From: John White
To: Diane Screnci; Eugene Cobey; James Noggle; Neil Sheehan
Date: Tue, Sep 19, 2006 7:51 AM
Subject: Fwd: FW: IPEC Stakeholder Bi-Weekly Well Report

From: Donahue, Patrick J [<mailto:PDonahu@entergy.com>]
Sent: Tuesday, September 12, 2006 11:45 AM
To: Timothy Rice; Larry Rosenmann; Kutzy, Paul; jrw1@nrc.gov
Cc: Mayer, Donald M; Adler, Joseph J.; Hollenbeck, Peter; Wilson, Daniel
Subject: IPEC Stakeholder Bi-Weekly Well Report

Attached please find the revised IPEC Groundwater Investigation Bi-Weekly Update. This nascent report was created in order to provide monitoring well data to the stakeholders in a manner that hopefully will assist the reader in understanding the monitoring well data both in both tabular form and graphically. We are attempting to create a single report that all will find useful. Our intention is to update this report the Wednesday preceding the scheduled bi-weekly stakeholder call on Thursday. This report will contain a data chart and data table of each wells particular data. The chart will more easily show data trends and how the data relates to the maximum concentration level (MCL). The data table will provide all sample results through pre

Trend Graph for Well: MW-34

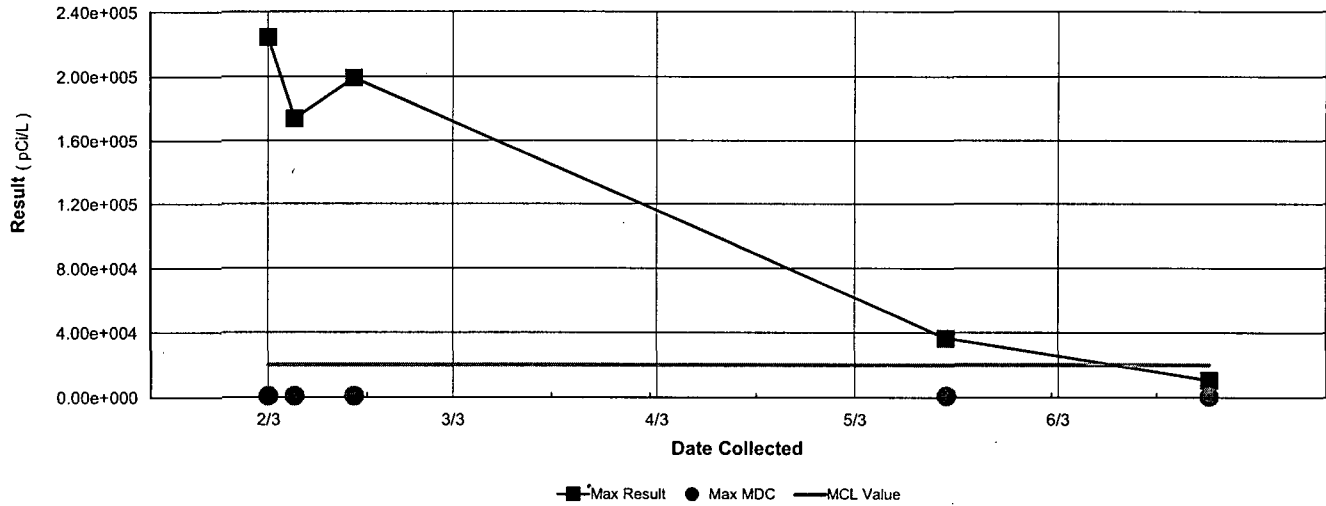
- Each report should be annotated similar to your explanation in your 9-12-06 e-mail.
- As discussed during our conference call, where samples are drawn from different levels there will be a separate report for each level as if each level represents a different well.
- Each report should indicate the current sampling frequency or next tentative sampling date.
- Well location should be categorized in each report and reports grouped accordingly, e.g. offsite, onsite perimeter, onsite interior, along river, relation to spent fuel rod pools, etc. You may have your own better convention. Tim Rice had suggestions.
- The reports should include a cover sheet which identifies, categorizes, and indicates status of, e.g. proposed, under construction, fully developed, etc., all monitoring wells.

Included are two examples of how a typical page will appear. The MW-34 chart shows how a well containing elevated concentrations of H3 would appear in addition to the identification of a trend in the data. Comparing this to MW-40 we see that wells close to background or having results less than the minimum detectable concentration will still have results plotted reflecting the 'non-detect' or background level of those results.
